Amendment #2
Port of Ilwaco Bulkhead Resilience Project

TO ALL PLANHOLDERS AND/OR PROSPECTIVE BIDDERS:

PORT OF ILWACO EAST BULKHEAD REPLACEMENT

Sheet Reference No.
S-201
INDEX: 17 OF 23

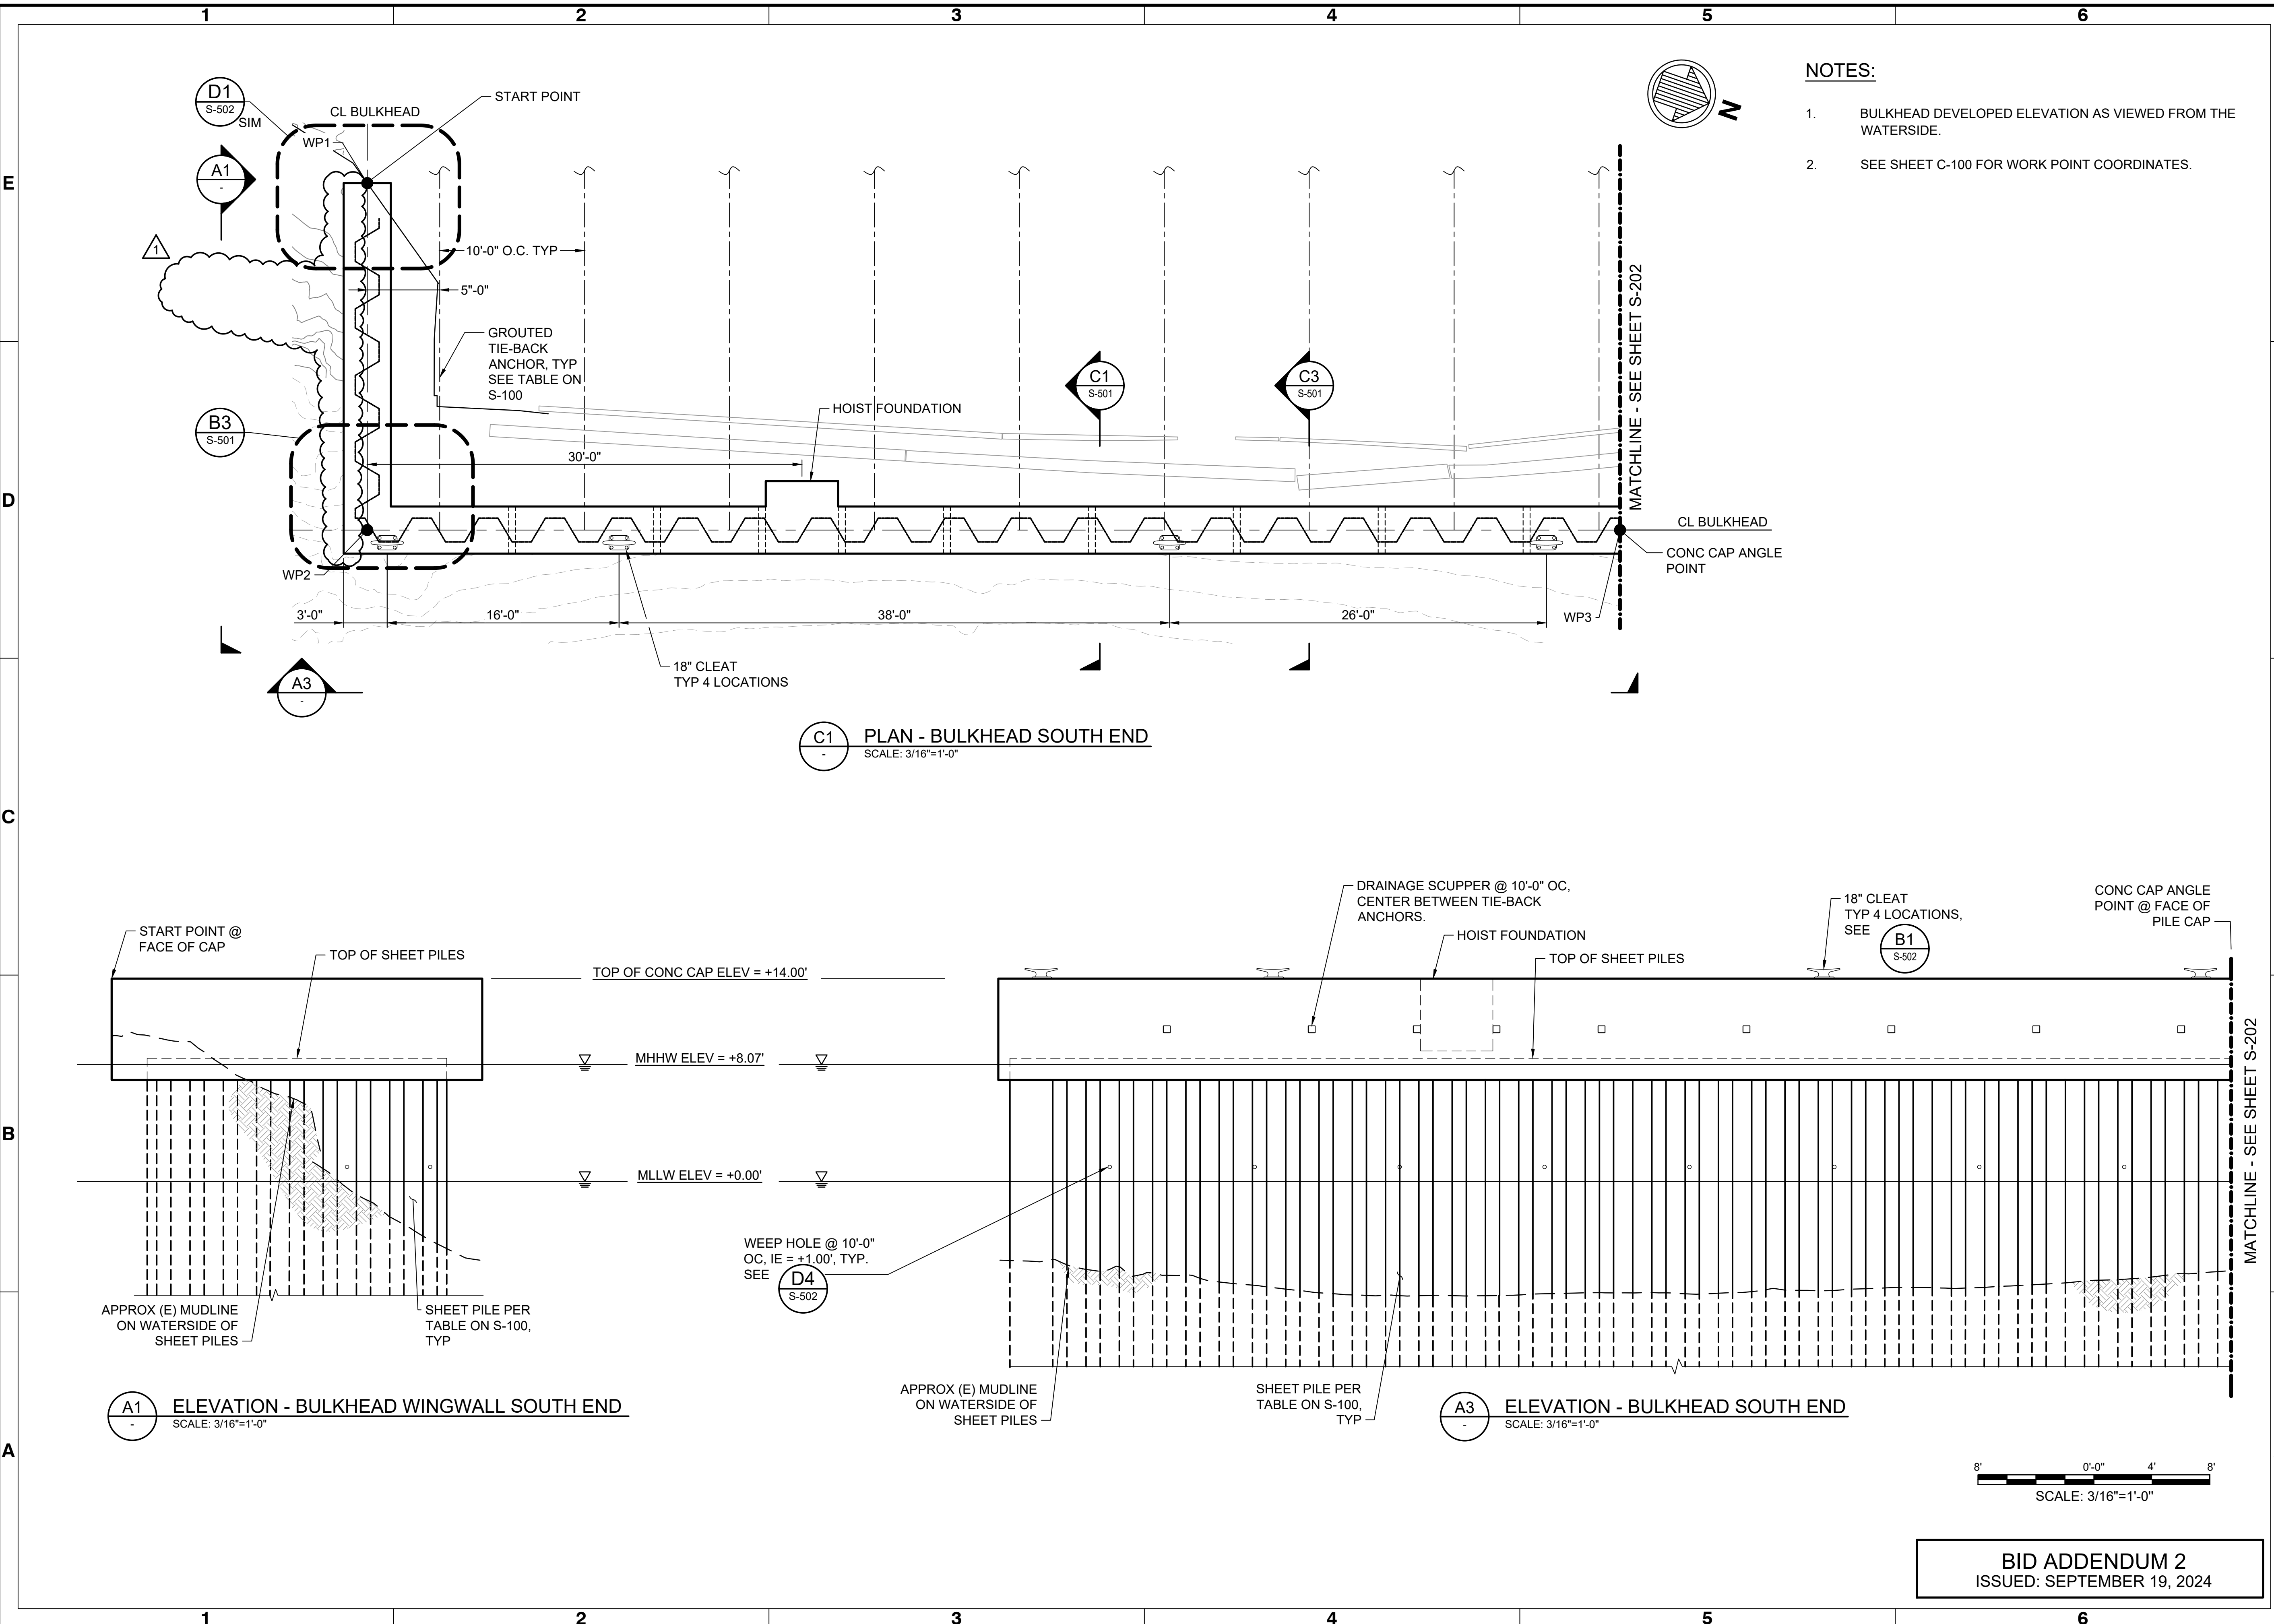
13. Detail C1 on Drawing Sheet S-201 calls out a Guardrail along the South End of the New Bulkhead Concrete Cap. Please provide details of the required fabricated Guard Rail.

A. No guardrail is required. Drawing S-201 has been updated to reflect this.
